September 30, 1977

Docket No. 50-271

The Commission has issued the enclosed Amendment No. 39 to Facility Operating License No. DPR-28 for the Vermont Yankee Nuclear Power Station (VYNPS). The amendment consists of changes to the Technical Specifications in response to your applications dated March 9, 1977; June 8, 1977; July 1, 1977, as supplemented; and September 16, 1977; and staff discussions.

Amendment No. 39
License No. DPR-28

Figure 3.11-3A
MCPR Operating Limit for 8x8 Fuel

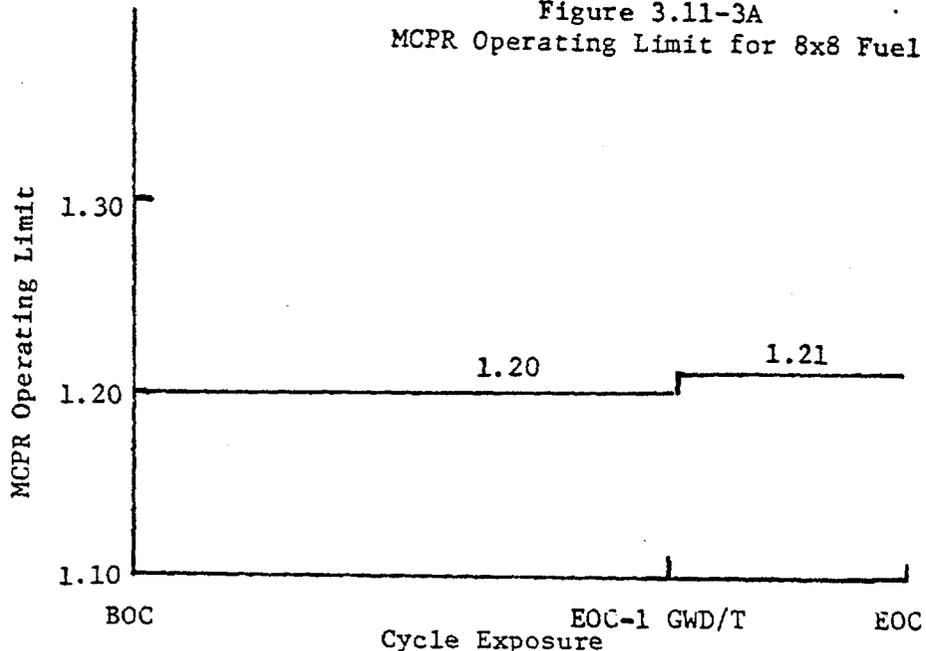
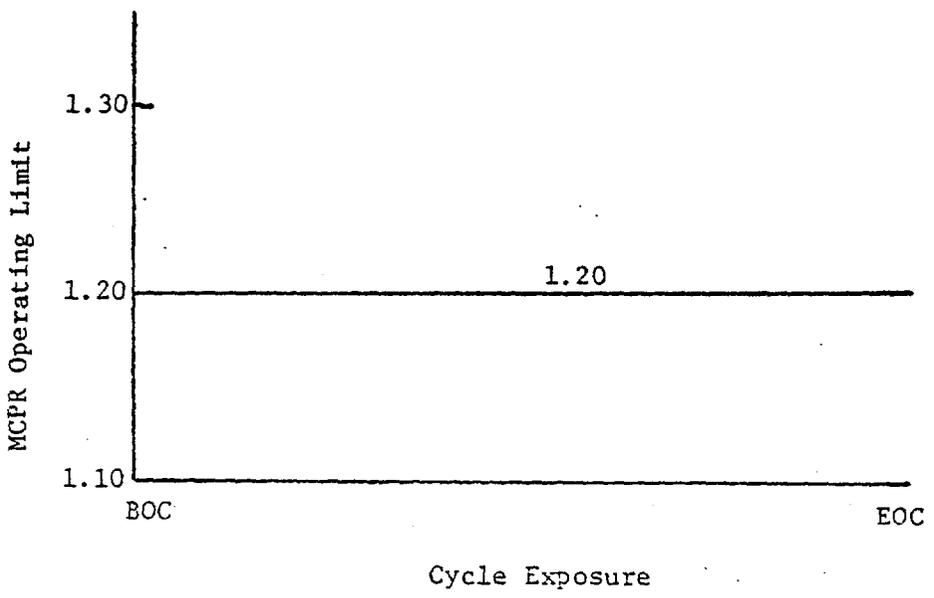
During steady state power operation the MCPR Operating Limit shall be equal or greater than the values shown on Figures 3.11-3A and -3B for 8x8 fuel and 7x7 fuel, respectively. For core flows other than rated the Operating MCPR Limit shall be the above value multiplied by K_f , where K_f is given by Figure 3.11-2. If at any time during steady-state operation it is determined by normal surveillance that the limiting value for MCPR is being exceeded, action shall be initiated within 15 minutes to restore operation to within the prescribed limits. If the steady state MCPR is not returned to within the prescribed limits within two (2) hours, the reactor shall be brought to the cold shutdown condition within 36 hours. Surveillance and corresponding action shall continue until reactor operation is within the prescribed limits.
